CITY OF TUALATIN

ARCHITECTURAL REVIEW FINDINGS AND RECOMMENDED DECISION

Case #: AR-95-53
Project: Oregon Auto Center
Location: 17795 & 17835 Pacific Highway (2S1 15C, 2192 & 2190)
Applicant: Steve Stolze

TUALATIN AUTO ARCHITECTURAL REVIEW GRADING PLAN

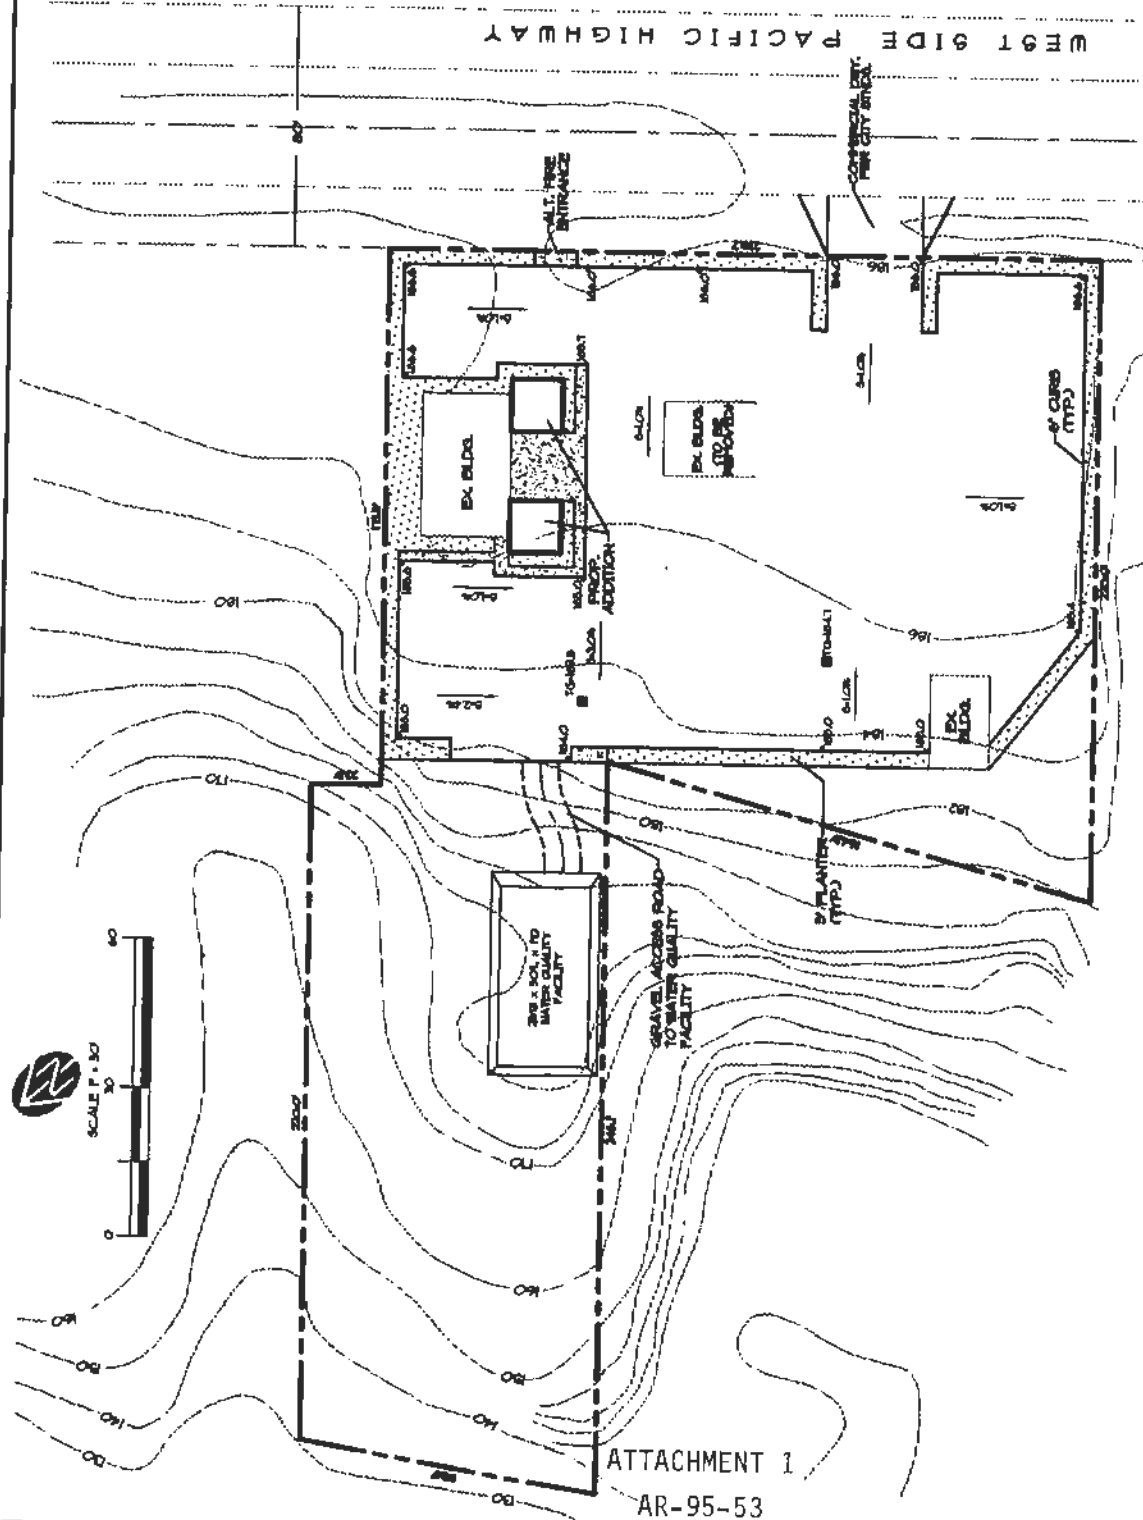
73.250(2)(a-b) requires fencing at the dripline of trees to be retained on site with chain link or other sturdy fencing. There are trees on this site larger than 8" in diameter within the development area boundary or adjacent to the development area boundary which have not been identified according to a staff inspection on January 16, 1996. All trees larger than 8" in diameter shall be identified and noted whether to be removed or retained and trees retained identified to have a chain link or other sturdy fencing places at the dripline during construction. No removal of trees shall occur off-site.

- a. Modifications made to the Site Plan shall be made to the Grading Plan and the two plans shall be consistent in site layout.
 - b. All trees larger than 8" in diameter shall be identified and noted whether to be removed or retained and trees retained identified to have a chain link or other sturdy fencing places at the dripline during construction. No removal of trees shall occur off-site.

TRASH ENCLOSURE ELEV.

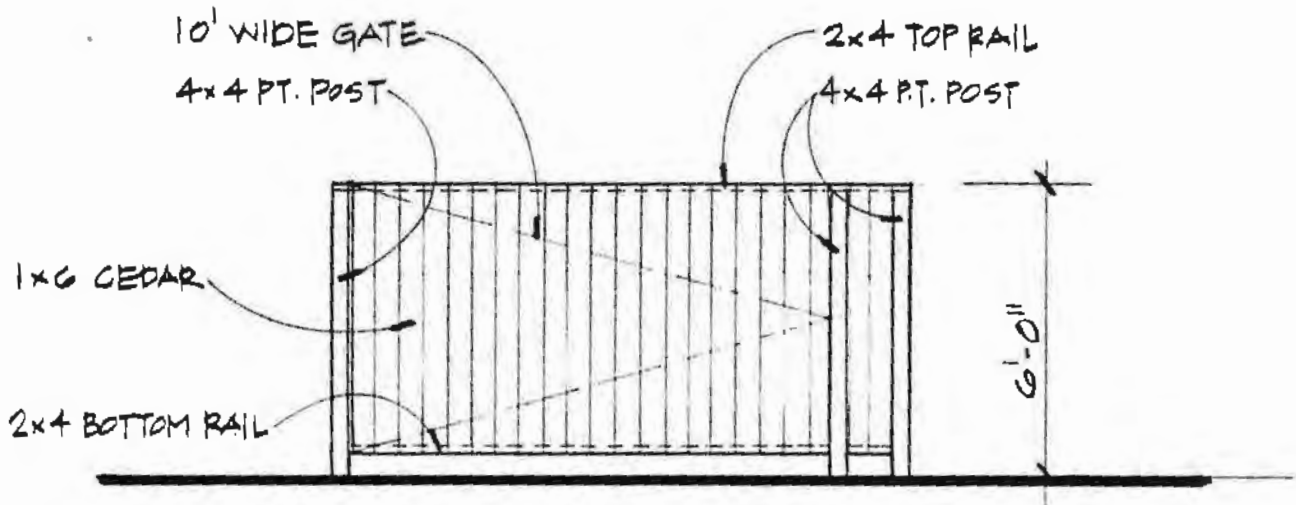
10. Mixed Solid Waste and Source Separated Recyclables Storage Areas Minimum Standards Method. Commercial, industrial, public and semi-public developments shall provide a minimum storage area of 10 square feet plus: Office - 4 square feet/1000 square feet gross leasable area (GLA); Retail - 10 square feet/1000 square feet GLA; Wholesale/Warehouse/Manufacturing - 6 square feet/1000 square feet GLA; Educational and institutional - 4 square feet/1000 square feet GLA; and other - 4 square feet/1000 square feet GLA [73.227(2)(v)]. The mixed solid waste and recyclable area for this development (Lot 1) is located along the west development area boundary line. A total of 19 square feet is required. The plan indicates an area of approximately 60 square feet will be provided which exceeds the minimum required. The design of the trash area has not been provided. In commercial development the enclosures are to provide 6' sight-obscuring walls, a 10'-wide gate, landscaping around the perimeter and a separate pedestrian access [73.227(6)(b & c)]. A design of the trash enclosure shall be submitted which complies with the requirements of 73.227(6)(b & c) and shall be submitted to

- AR-11. A design of the trash enclosure shall be submitted which complies with the requirements of 73.227(6)(b & c) and shall be submitted to the Planning Department for review and approval prior to issuance of a building permit.

SITE PLAN

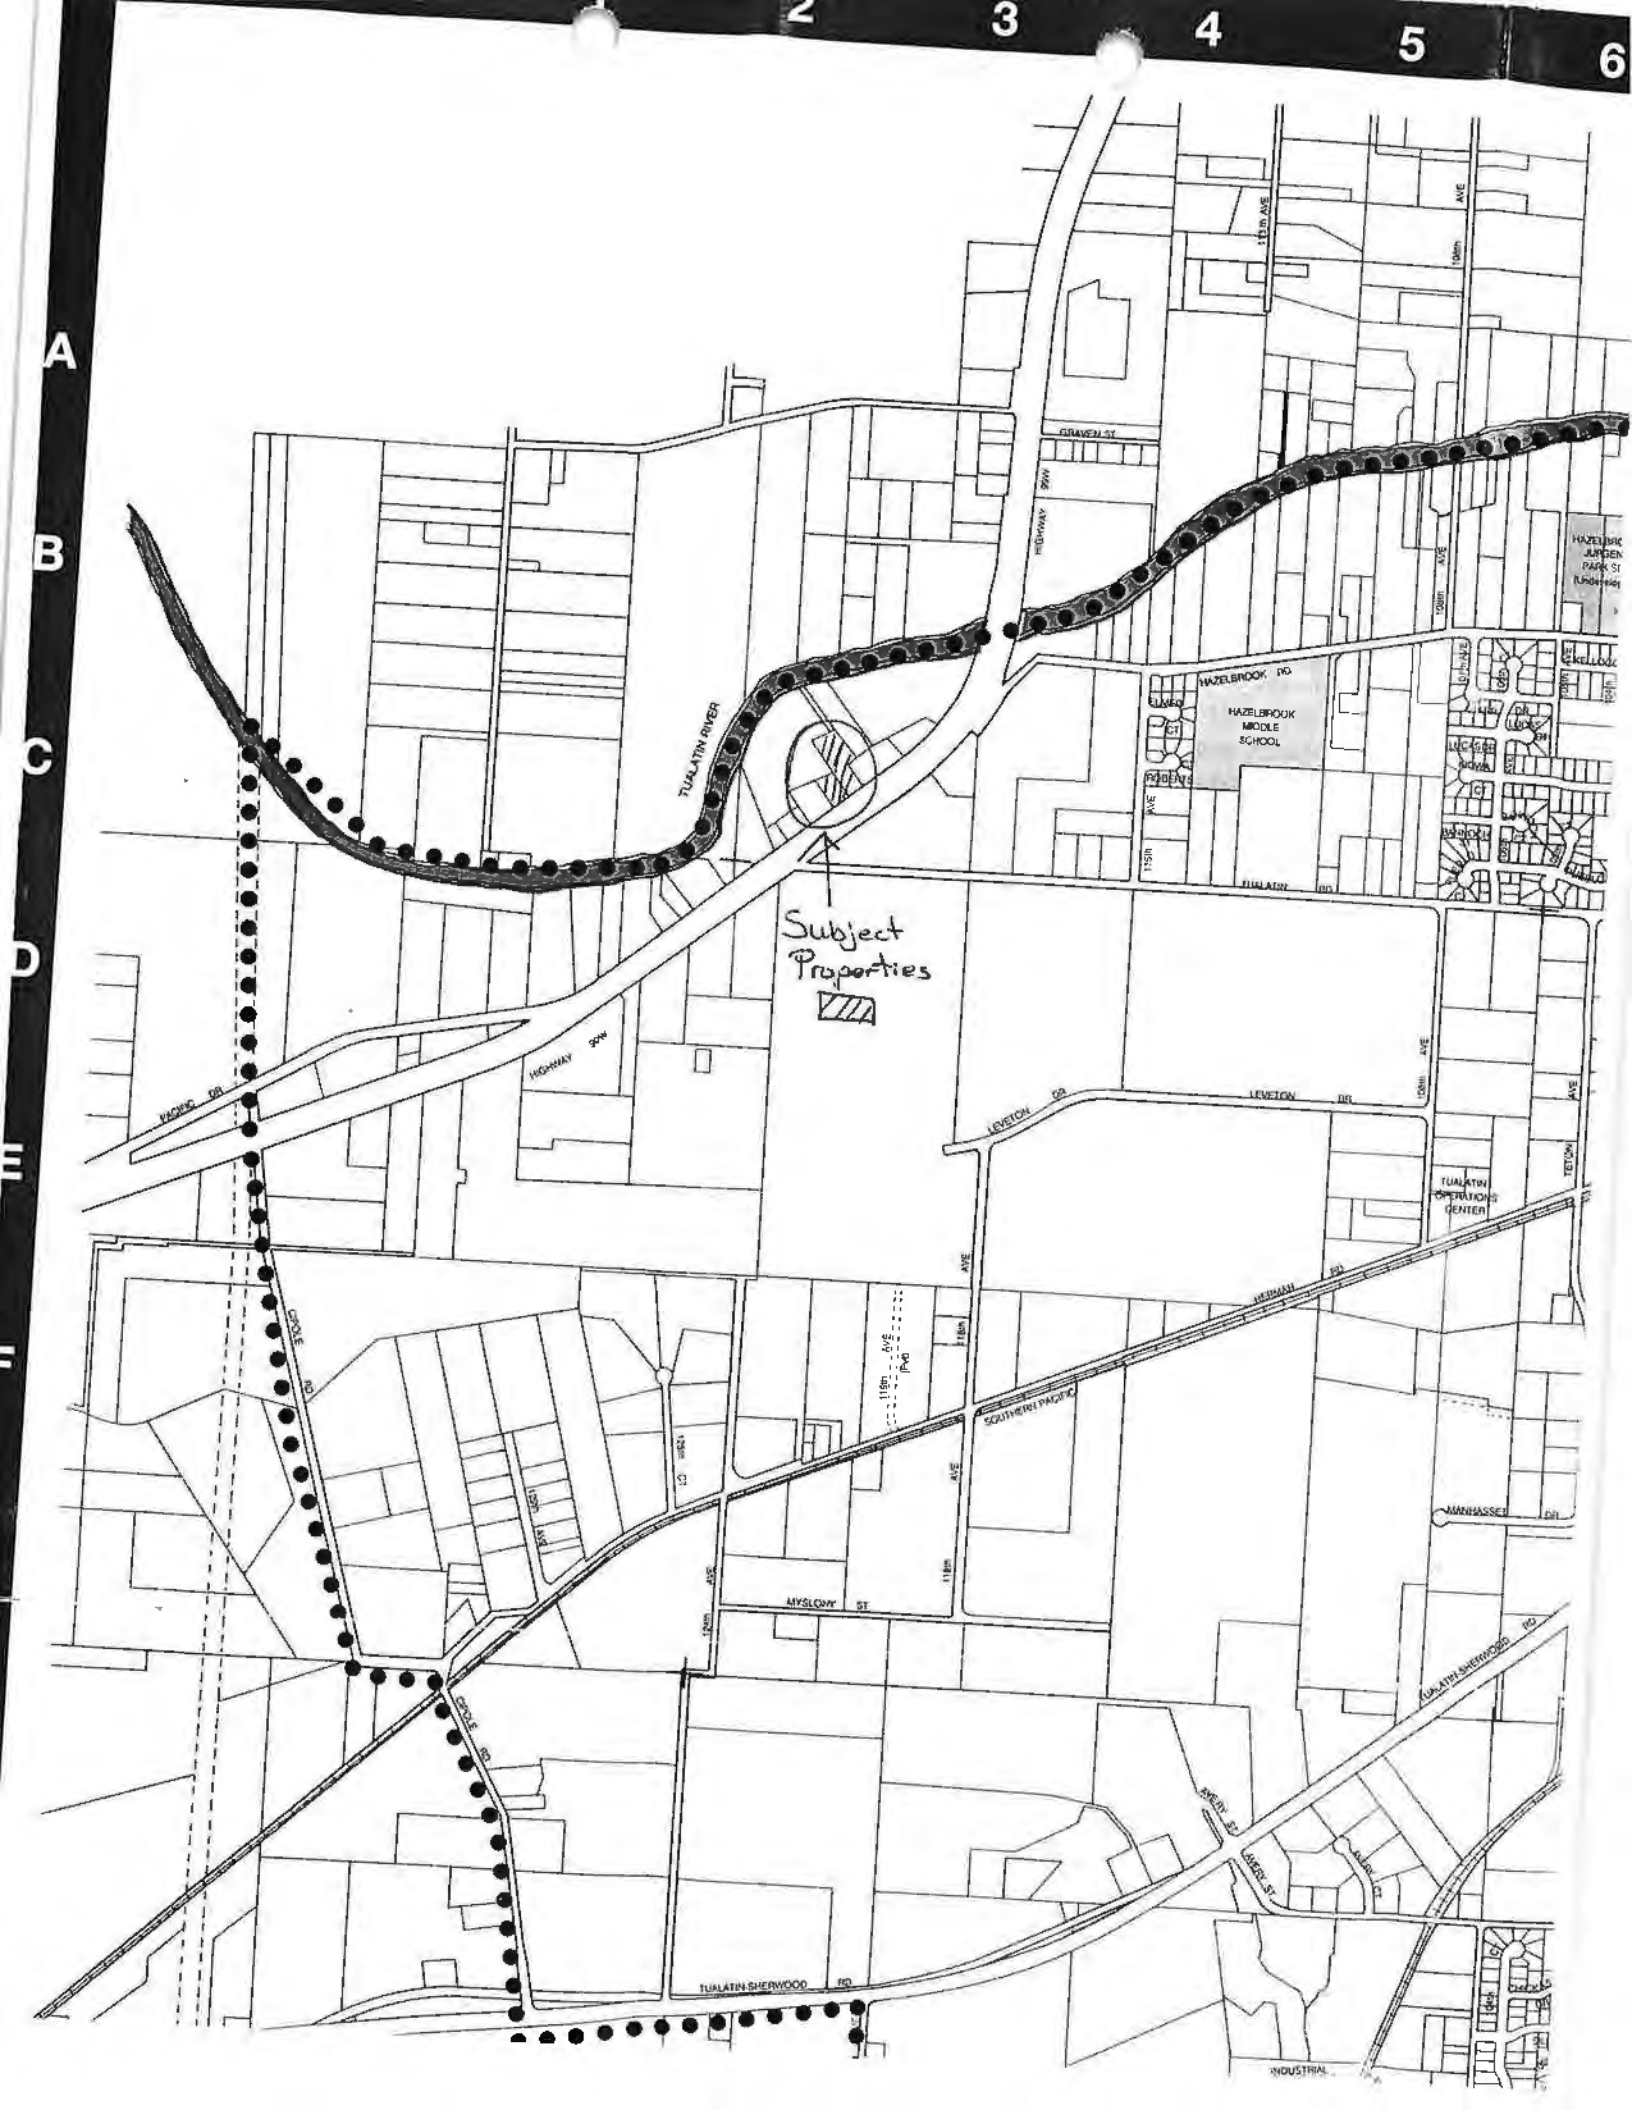
Plant trees

Need h.s. island in delete space
